Report: TAB Report
Function: Test, Adjust, & Balance
Date: 03/28/2025
Completed By: National TAB

Springer School Addition (Cincinnati, OH)

Issue List

M101

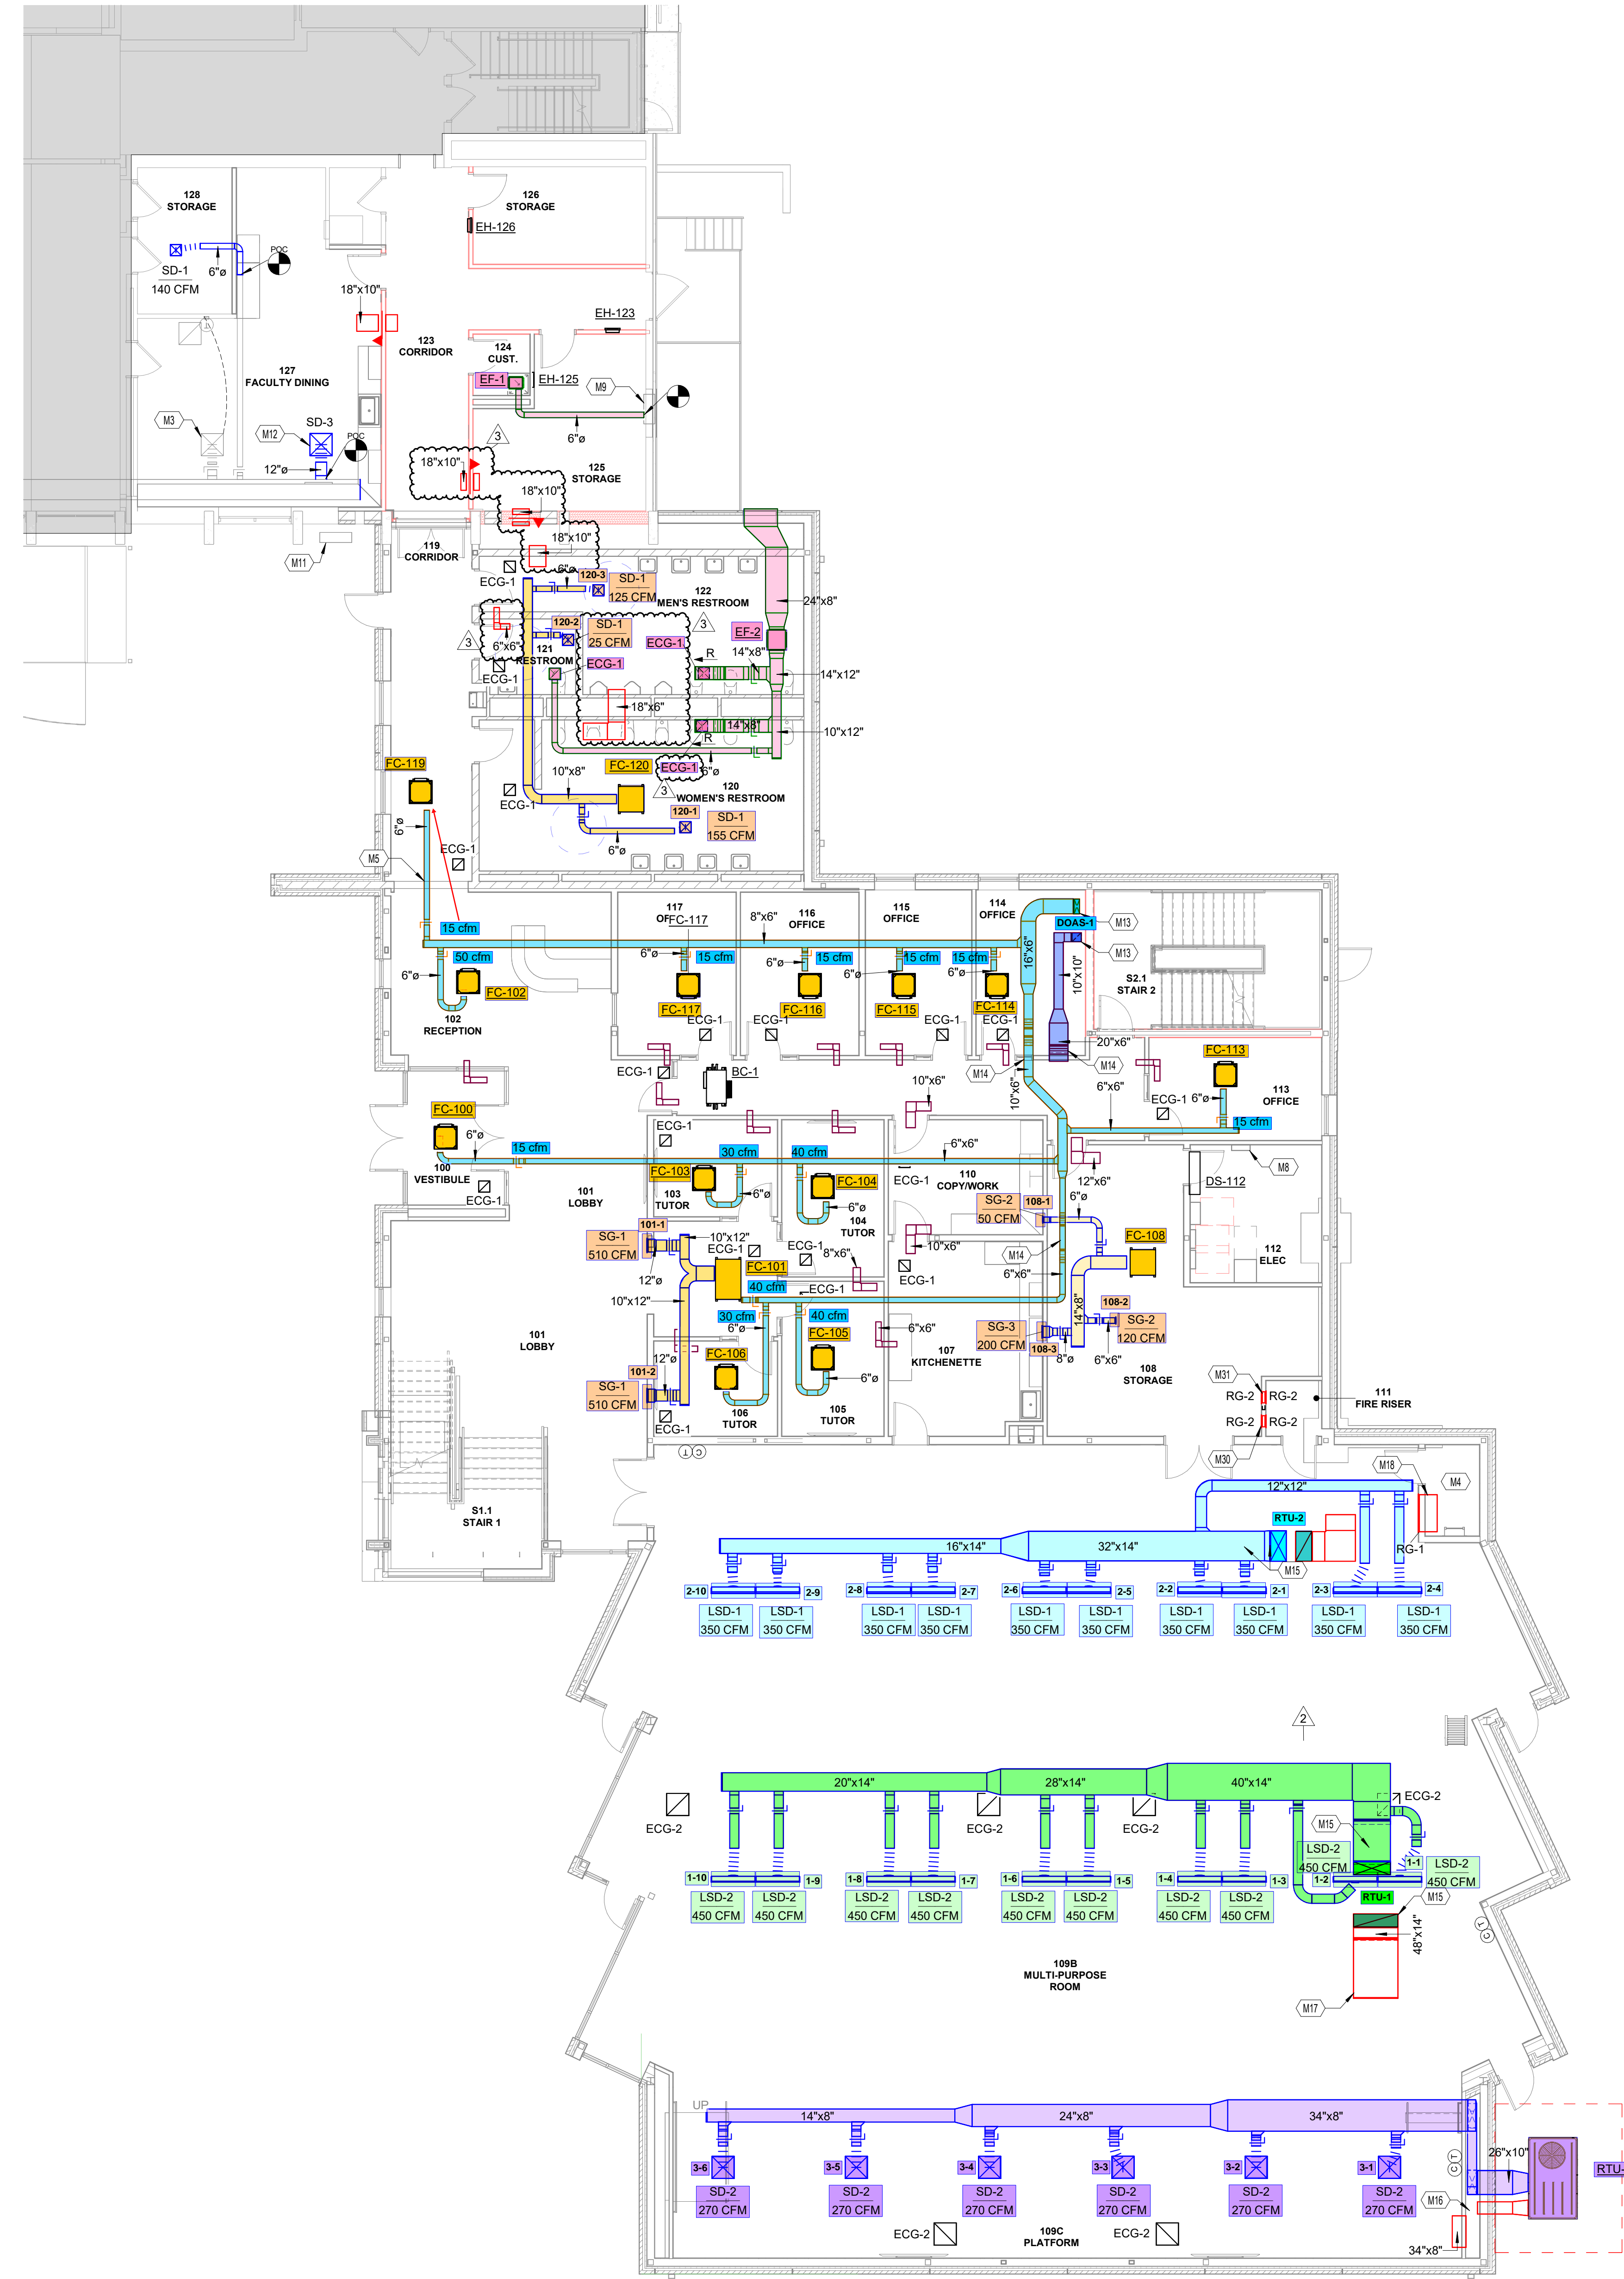
Issue Name : DOAS Return Unbalanced
Description : Returns for DOAS above ceiling were unable to be balanced evenly due to missing and jammed dampers. Return airflows air similar to supply air totals and should not disproportionately affect any of the three floors.
Created By : National TAB **Assigned To :** National TAB - Jordan Best
Status : Open
Priority : Low **Asset Tag :**
Originated Date : 12/20/2024 - Jordan Best - National TAB
